Proposal for Supplement 2 to the 02 Series of Amendments to UN Regulation No. 134 (Hydrogen and Fuel Cell Vehicles)

Submitted by the Task Force amending UN Regulation No. 134 *

I. Proposal

"Figure 2

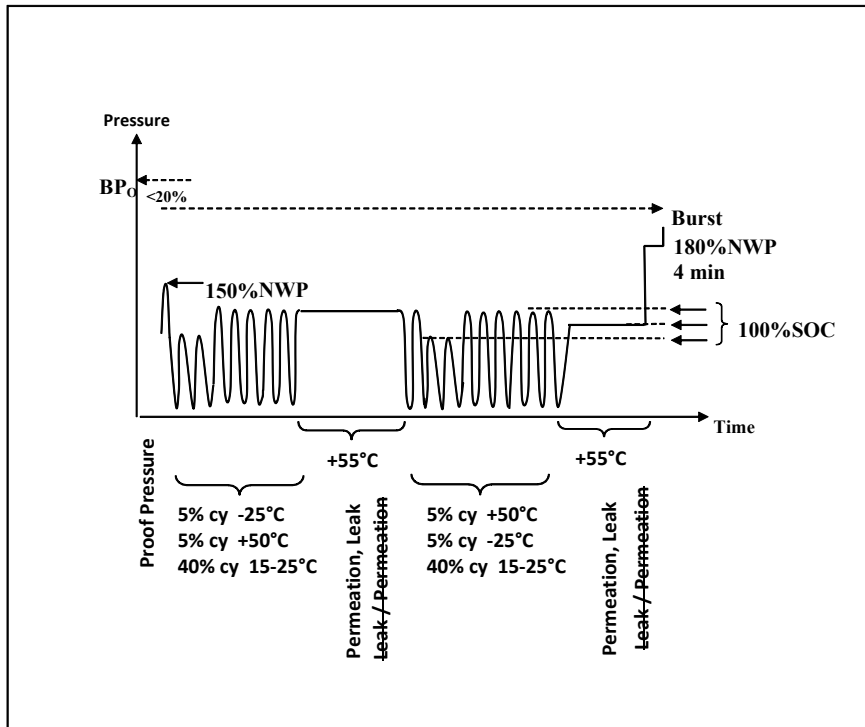
Figure 2., amend to read:

Verification Test for Expected On-Road Performance (Pneumatic/~~hydraulic~~)

This proposal clarifies the order of the permeation and leakage tests in Figure 2 so as to be in line with the text, and also streamlines the wording for headings and text relating to these tests.
